UNITED STATES PATENT AND TRADEMARK OFFICE

10/606,304

Office Action Summary

DETAILED ACTION

FIG. 8

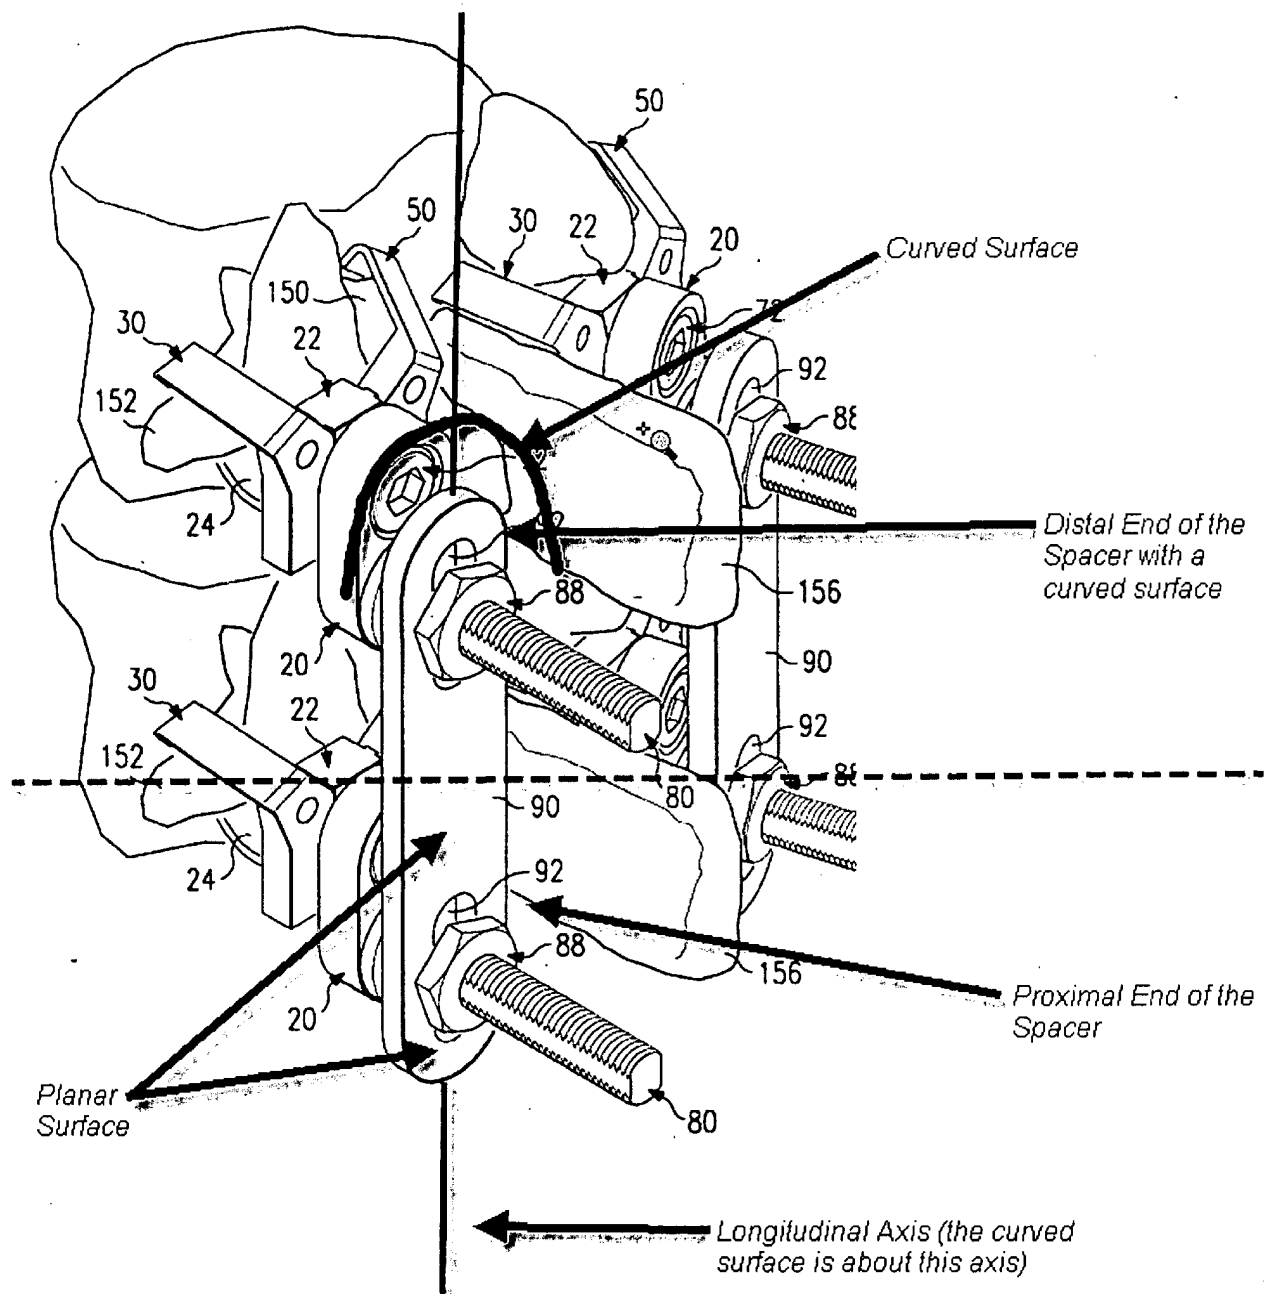
Applicant asserts that the Lee et al. Reference does not disclose a spacer with "a distal end with a curved surface formed about an axis and a proximal end that is planar, wherein the axis is parallel to the plane of the proximal end." The examiner respectfully disagrees that the Lee et al. reference does not disclose those limitations. Below the examiner is providing marked-up figures to illustrate that the Lee et al. reference does indeed meet those limitations.

The Spacer (ref. #90) still meets the newly added claim limitations regarding the locations and orientations of the curved and planar surfaces of the spacer as shown in

the above figure. Similar is true for the second interpretation for claims 7 and 8, which refers to ref. #70 as the spacer rather than ref. #90.
